Re: TDI Diesel Generator Owners Group
Revision 1 of Final DR/QR Report
for the Transamerica Delaval Diesel
Generators at WPPSS Nuclear Project 1
File: MTS-4086

**DESIGN REVIEW
AND
QUALITY REVALIDATION
REPORT**

WPPSS NUCLEAR PROJECT 1

TDI DIESEL GENERATOR OWNERS GROUP

FIGURE 1
EXHAUST MANIFOLD PIPING

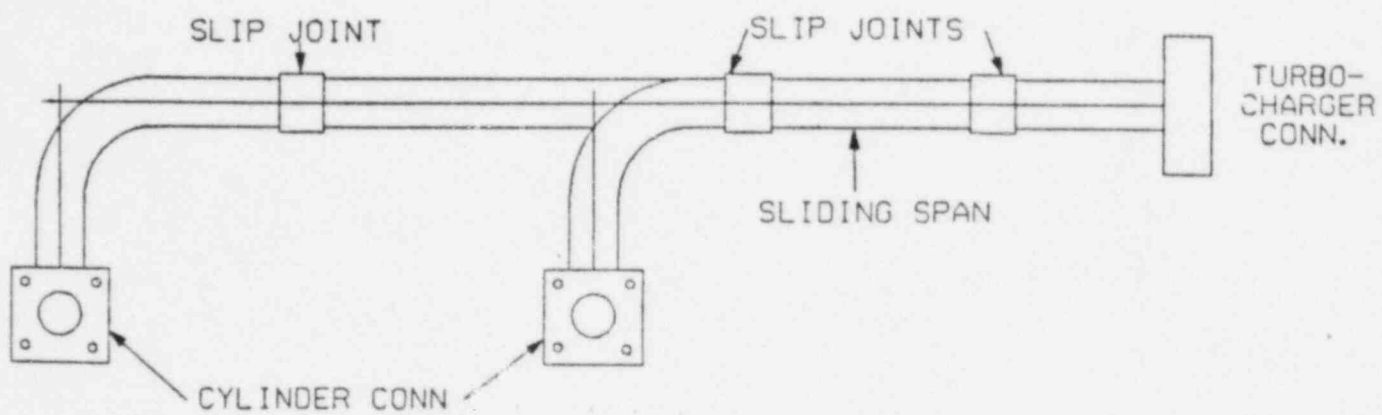
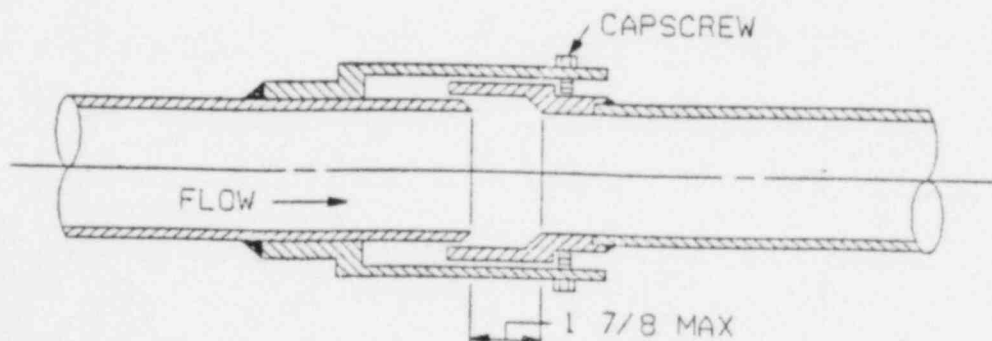
It is expected that friction from the seals in the slip joints will provide sufficient force (approximately 142 lb.) to move the sliding span along with the adjoining pipe during a seismic event while allowing relative thermal movements. The seismic displacements and rotations at the slip joint are negligible (displacements approximately .1 inches, rotations approximately .015 radians). Even if the friction force is inadequate to keep the sliding span moving with the adjoining pipe sections, restraining devices are provided to prevent separation of exhaust piping. The gap associated with the slip joint at both normal operating and ambient temperatures is much larger than the total relative movements of the adjacent piping. Therefore, no significant impact between the sliding span and adjacent piping will occur.

Based on this evaluation (Reference No. 2), the exhaust manifold piping has been found to be acceptable without modification. All stress levels remain well below code allowables (maximum stress ratio of approximately 0.4). Nozzle loads are not significantly increased from those approved in the original calculation. Relative movements at the slip joints are very small and the restraining devices are adequate to prevent any lock up or separation of the exhaust piping.

The exhaust manifold piping as designed and installed by Transamerica Delaval, Inc. is adequate to perform its intended design function.
